Submission to Central Precinct rezoning proposal

The City has reviewed the draft Explanation of Intended Effects (EIE), Design Guide, Planning Report, and supporting technical studies. **The City objects to the following aspects of the proposal**, which need to be more fully resolved to position development at Central Precinct for long term success:

Figure 3. Analysis of how the masterplan has been derived

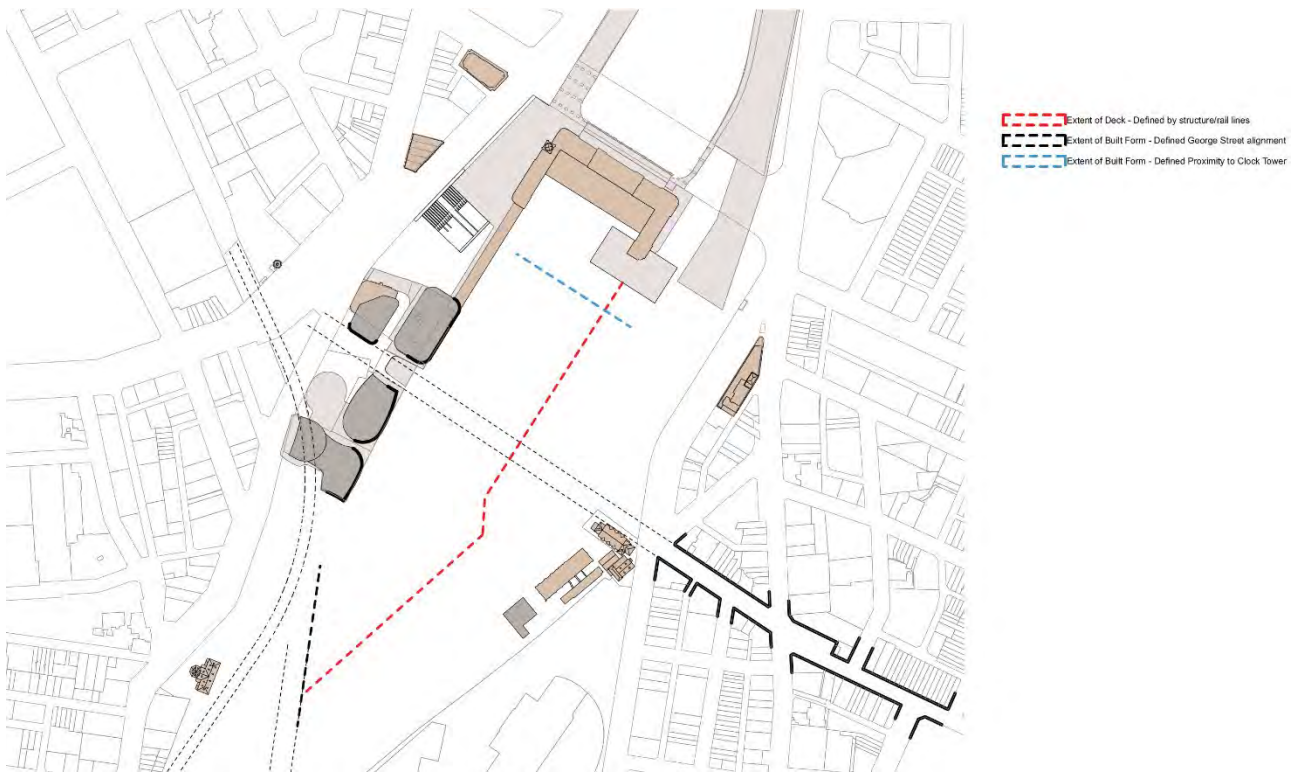
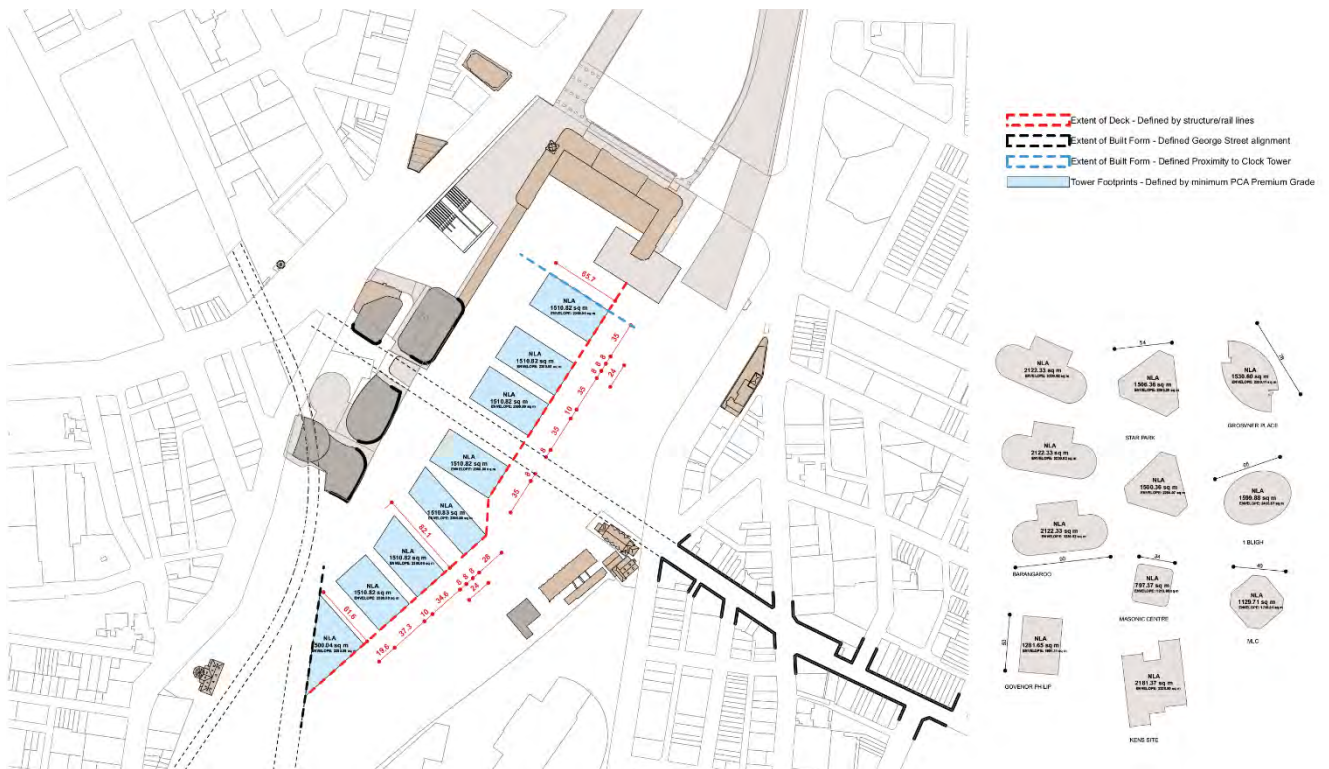
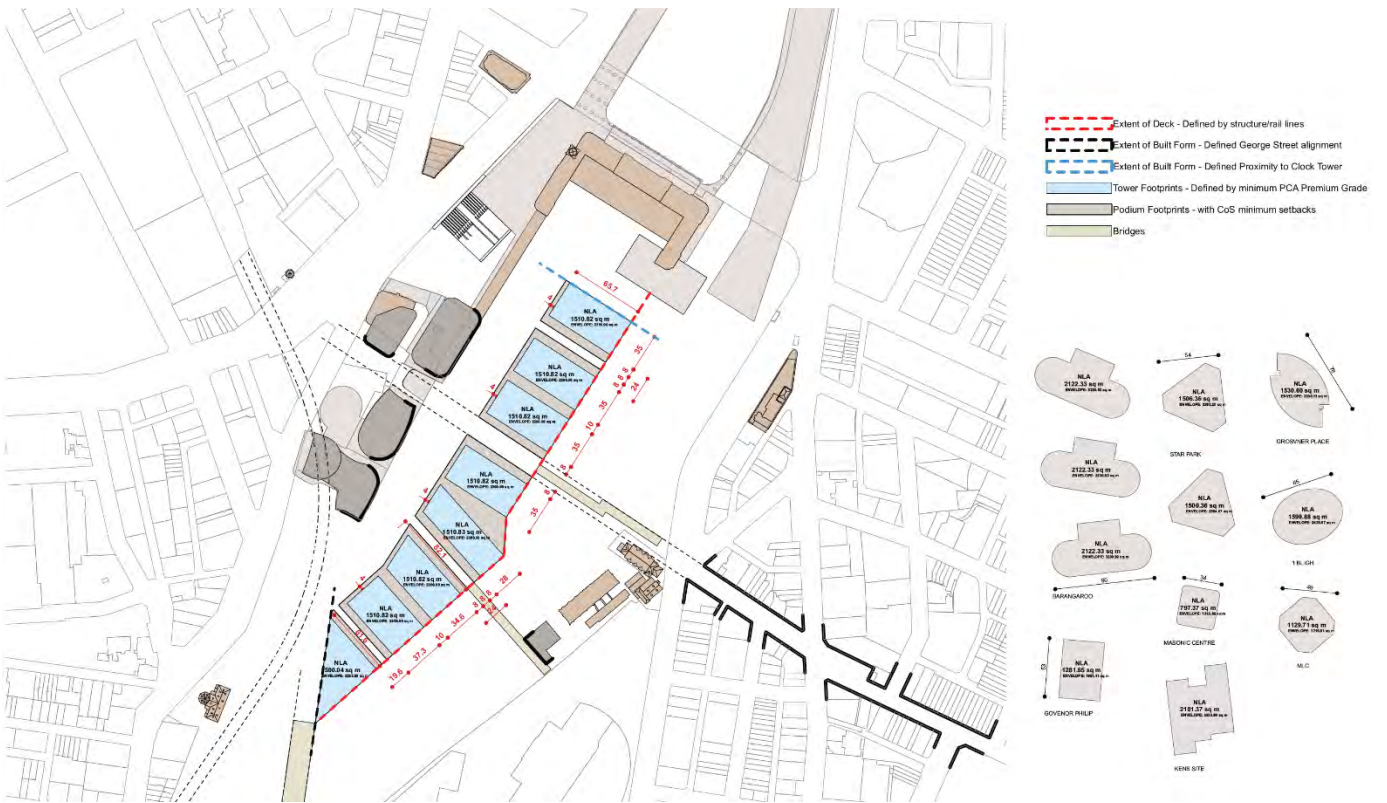
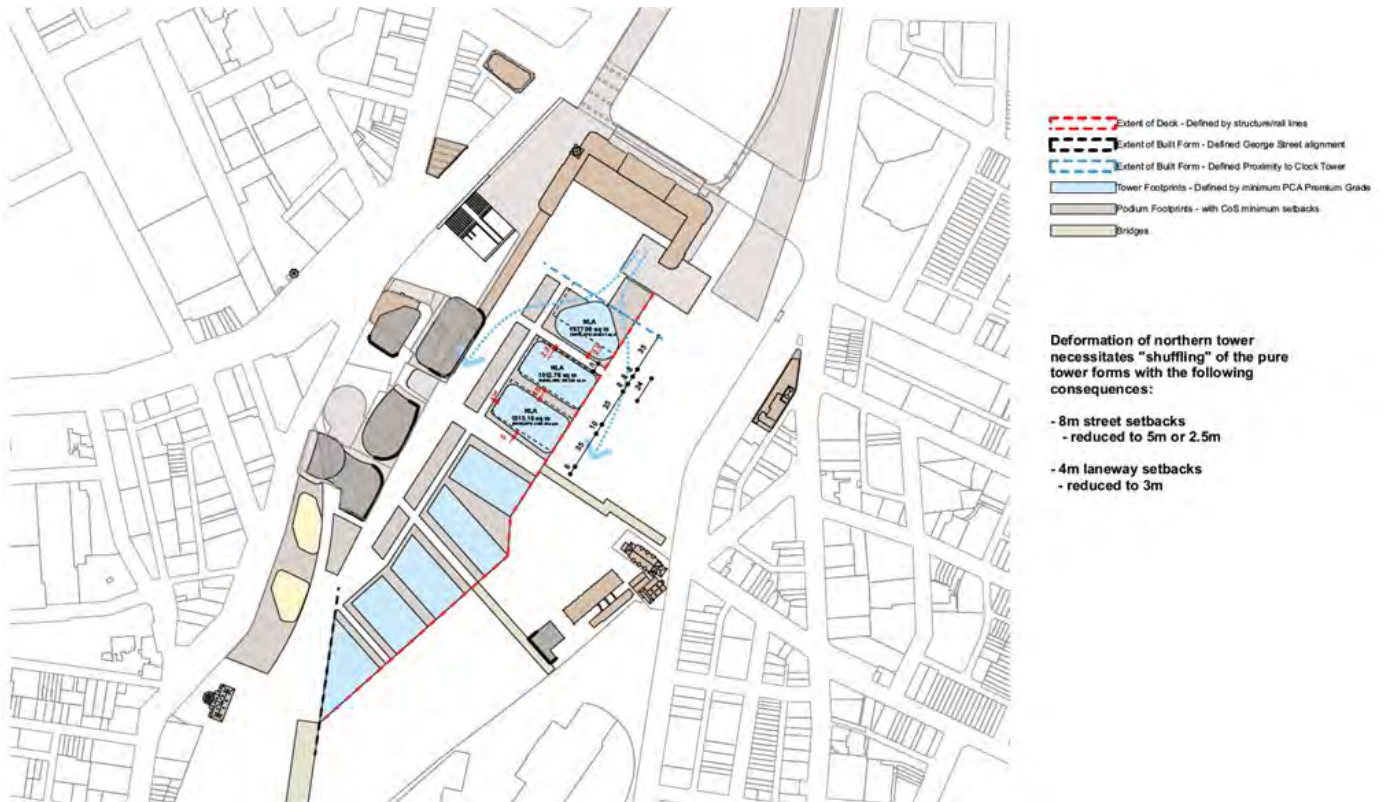
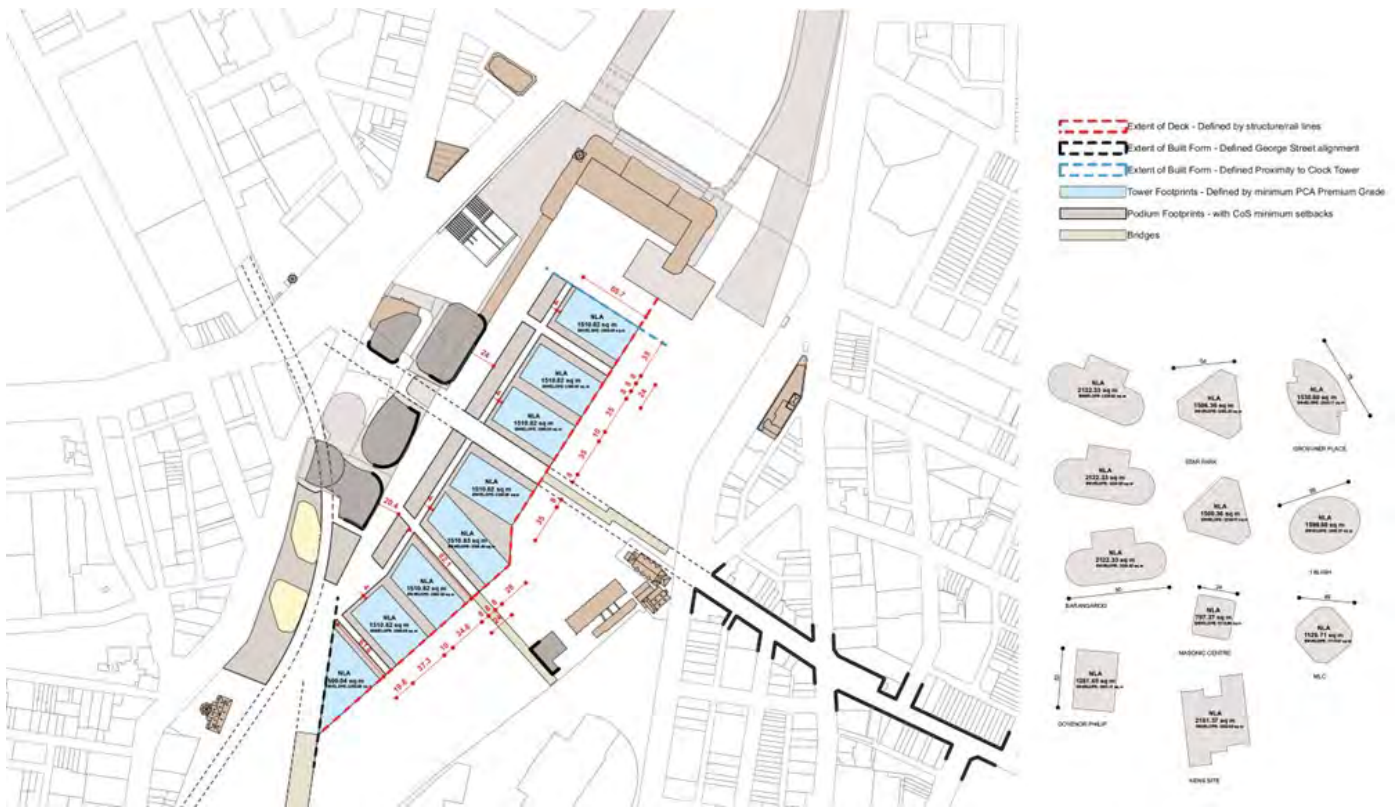
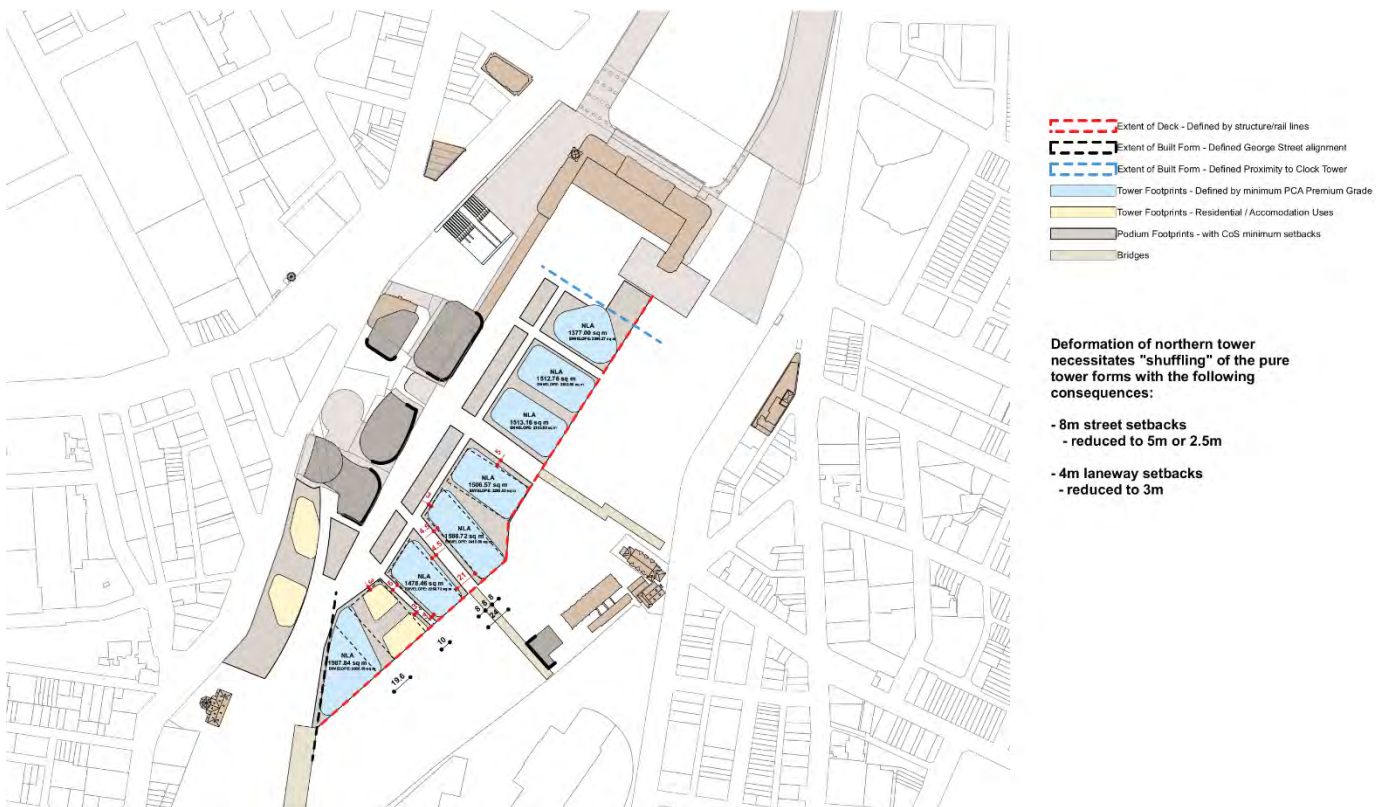
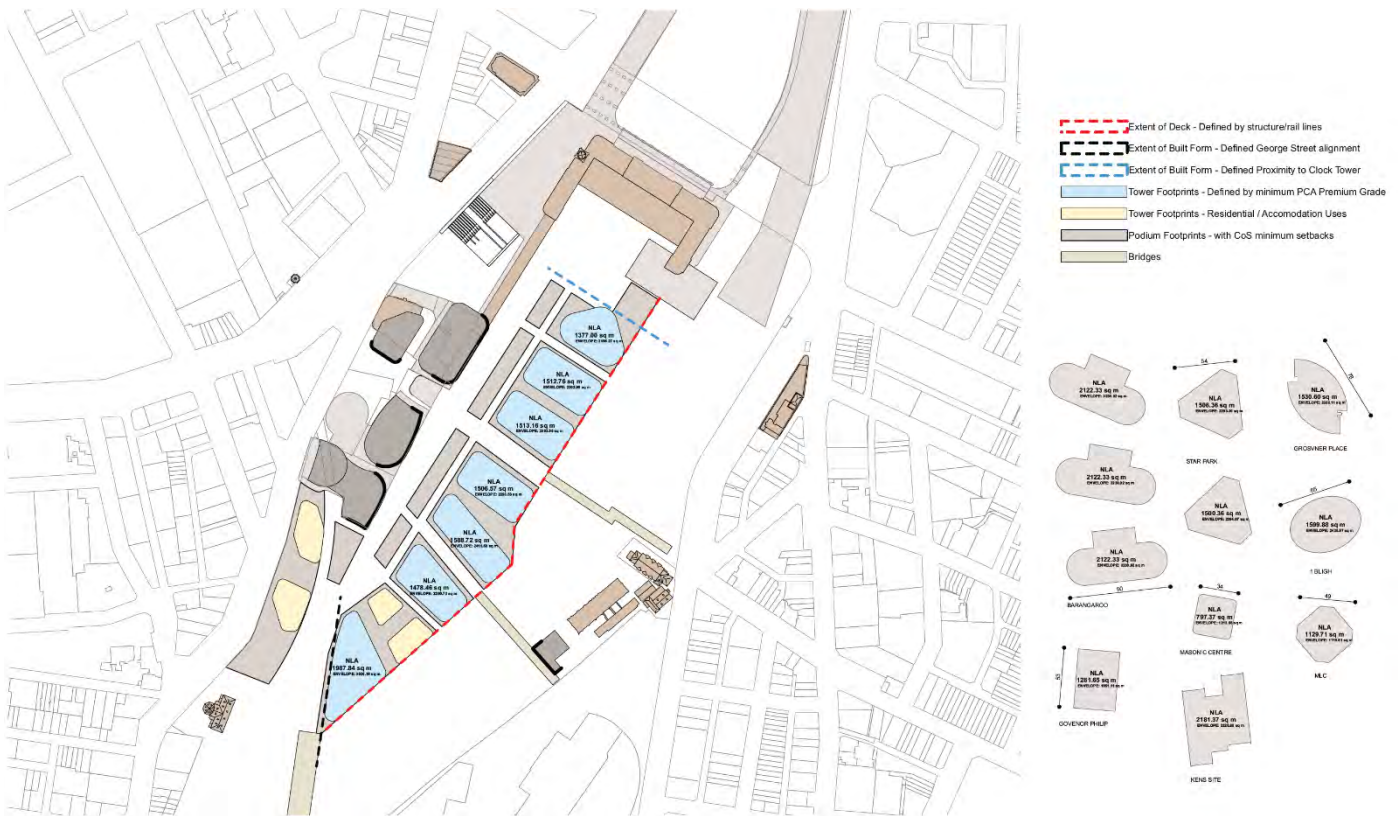
The proposed masterplan has been derived from a principle of optimising premium grade commercial floorplates, illustrated in Figure 3. This results in too many towers, that are too close together at the expense of the public realm. It results in streets and open spaces that have poor sunlight and poor wind conditions, and connections from the surrounding streets and spaces that are narrow, steep and not legible.

The City does not support the optimisation of premium grade office space as the primary driver for the planning of this important precinct. If this precinct is to form a part of the city fabric, it must be designed around the placement of high-quality open spaces with good solar access, daylight and comfortable wind conditions. The location of buildings must be the result of the prioritisation of good open spaces, not the other way around.

Recommendation: The buildings envelopes should be updated to include a greater diversity of building types, to provide workspace, which is appropriate and adaptable for the innovation precinct.

Figure 4. Exhibited reference design breaks the sun access plane

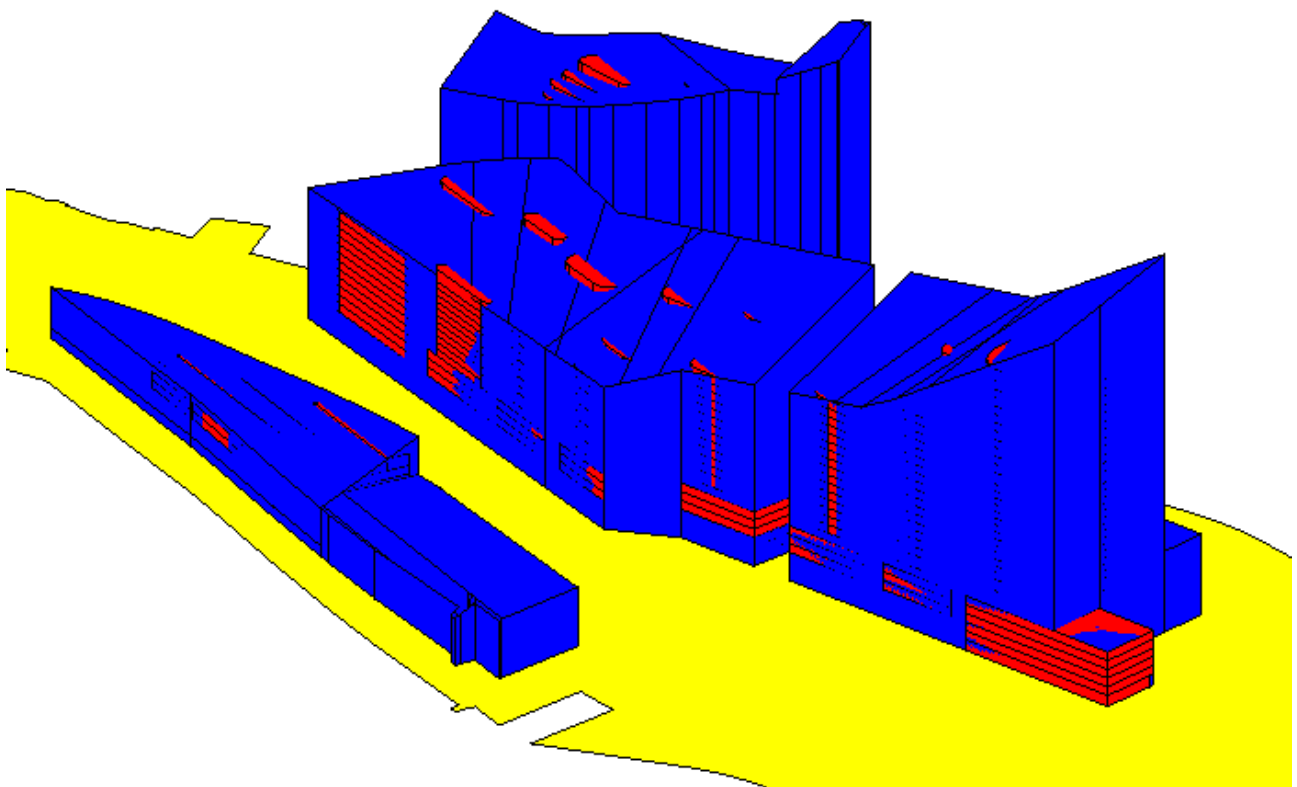
It is also noted that the building envelopes exhibited break the Sun Access Planes in several locations as shown in Figure 4. The building heights must be reduced, and the GFA re-calculated.

Recommendation: Reduce the building heights under the Sun Access Plane.

Figure 5. Proposed reference design

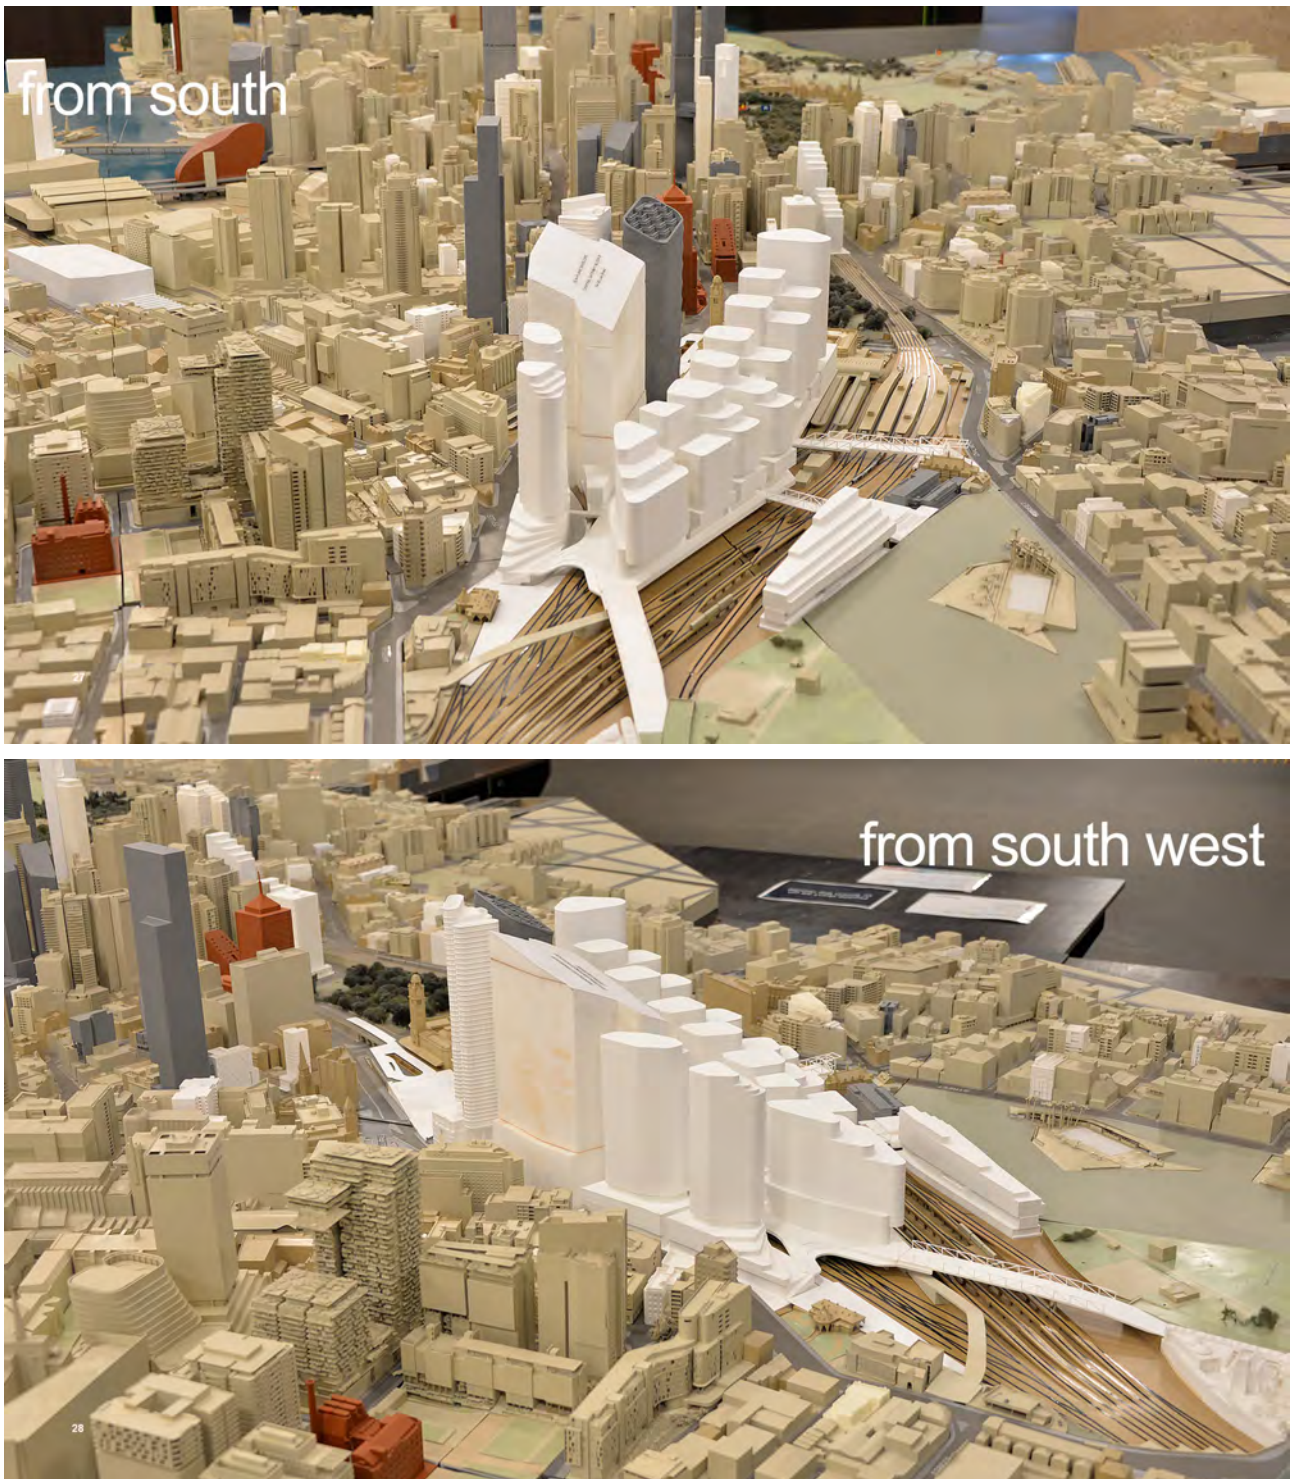
It is noted that the 3D model and CAD model supplied as part of the exhibition process are not building envelopes, rather a representation of the reference design possible within the building envelopes. This is misleading and is not a true representation of the scale of development possible under the proposed planning controls. In particular, the envelope for the Prince Alfred Park building is far larger than the reference scheme illustrated in Figure 5.
